Product Change Notice (PCN)

Subject: Carrier Tape change for Renesas Product ISL91108* WLCSP Packaged Product

Carrier Tape dimension change for Renesas Product ISL91108* WLCSP Packaged Product

Appendix A- Comparison of Carrier Tape Dimension

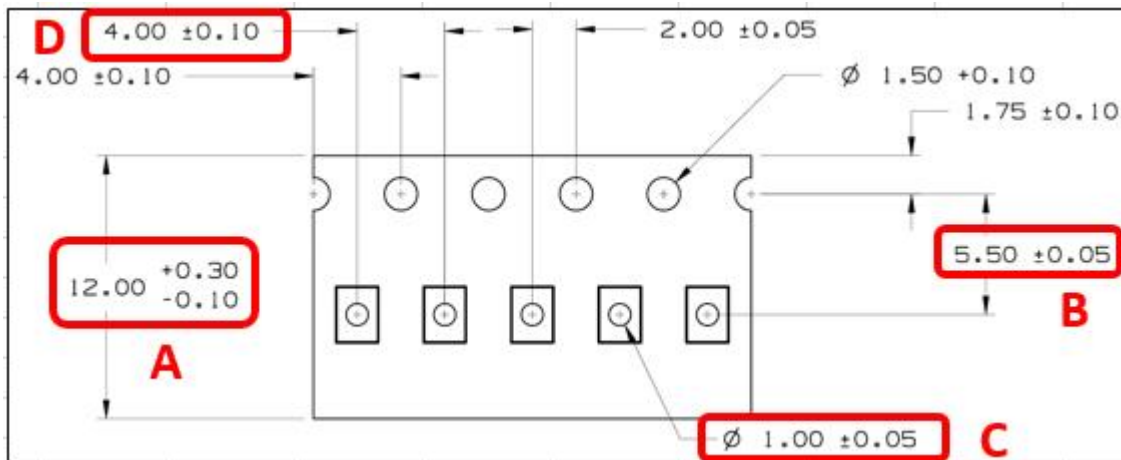
1. Lokreel width comparison table was removed. Because the carrier tape width will maintain as 12mm, therefore there is no change to the lokreel width.
2. The new carrier tape width (Code "A" as shown in Appendix A) will maintain as 12mm (no change)
3. The corresponding pocket dimension were revised as outlined in Appendix B.

This notice is to inform you that Renesas has qualified a change that standardizes the Carrier Tape used for tape and reel packing of the listed Renesas ISL91108* WLCSP (Wafer Level Chip Scale Package) packaged products. The changes are not expected to affect the automated pick and place equipment used for board mount assembly operations. The differences are outlined in Appendix A and B.

#	Code	Dimension	Existing Carrier Tape	New Carrier Tape	Summary
1	A	Carrier Tape Width	12.00 mm + 0.30 mm - 0.10 mm	12.00 mm + 0.30 mm - 0.10 mm	No change
2	B	Index Hole to Pocket Hole Width	5.50 mm ± 0.05 mm	5.50 mm ± 0.05 mm	No change
3	C	Pocket Hole Diameter	1.00 mm ± 0.05 mm	1.00 mm ± 0.05 mm	No change
4	D	Carrier Tape Indexing pitch	4.00 mm ± 0.10 mm	4.00 mm ± 0.10 mm	No change
